Questions on Notice from IPC and DPE Meeting 20 March 2019 – Narrawallee MP 06 0276 MOD 3

Figure 1: Approved Plan of Subdivision

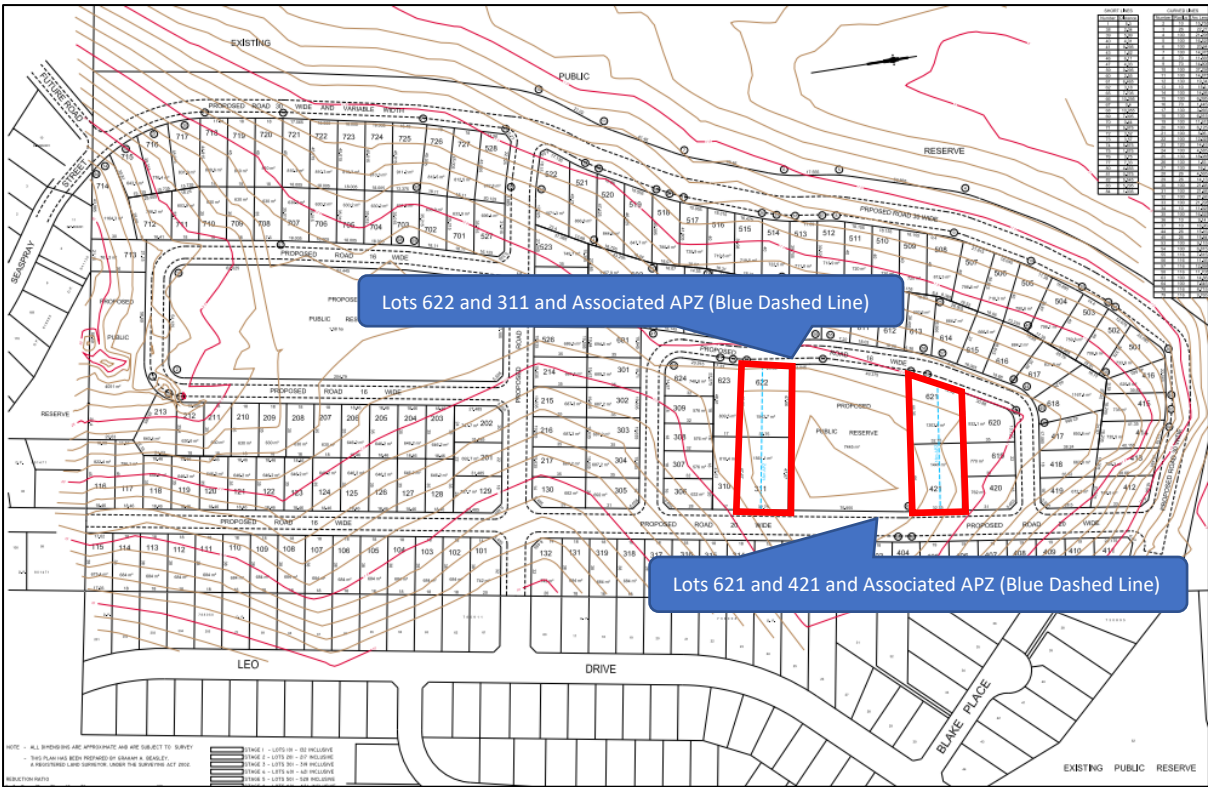
3. How many additional lots did the original modification request propose in the northern vegetated reserve? (i.e. two or four?)

The original modification request sought approval to re-subdivide lots 621, 622, 311 and 421 to create 4 additional lots (see **Figures 1 and 2** overleaf).
